**REMARKS**

**IN THE DRAWINGS**

FIG. 9

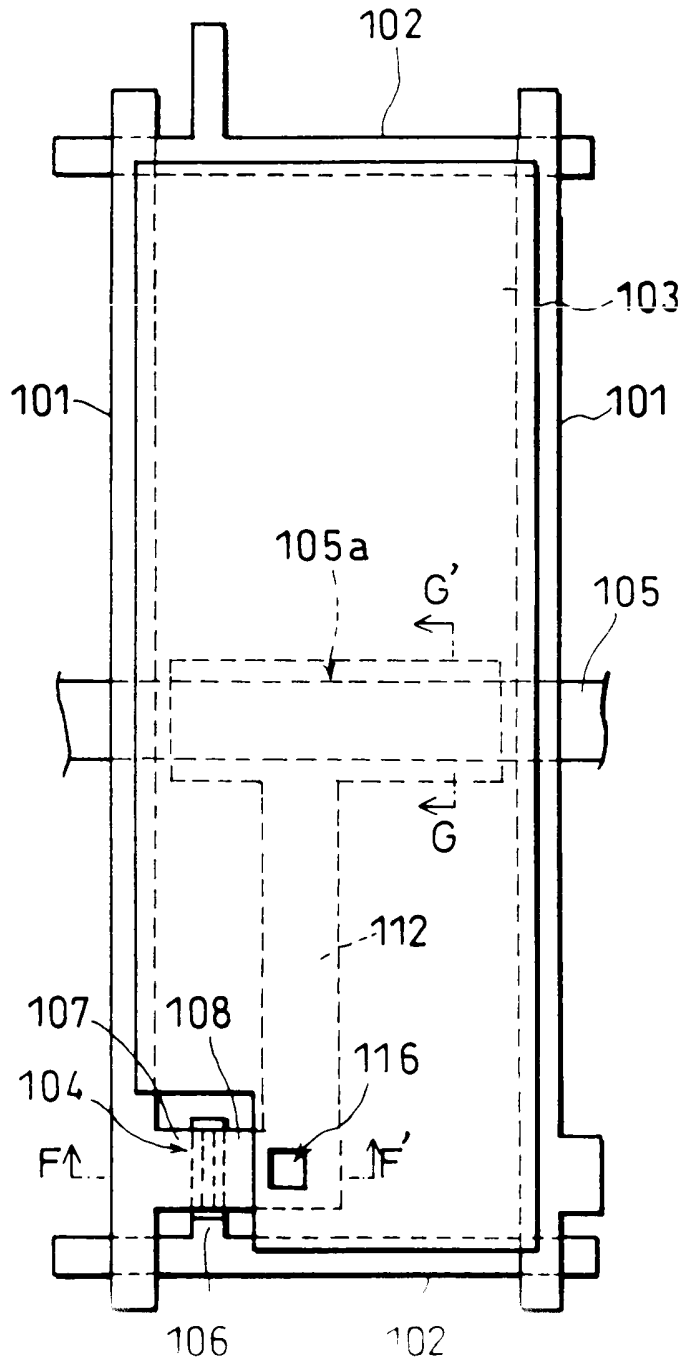
With respect to the objection to the drawings, Applicant has filed herewith a proposed drawing correction in which "Prior Art" labels have been added to FIGS. 9-13. Approval of the proposed drawing corrections are respectfully requested.

The attached replacement sheets of drawings include changes to Figs. 9-13. The replacement sheets, which includes Figs. 9-13, replaces the original sheets including Figs. 9-13.
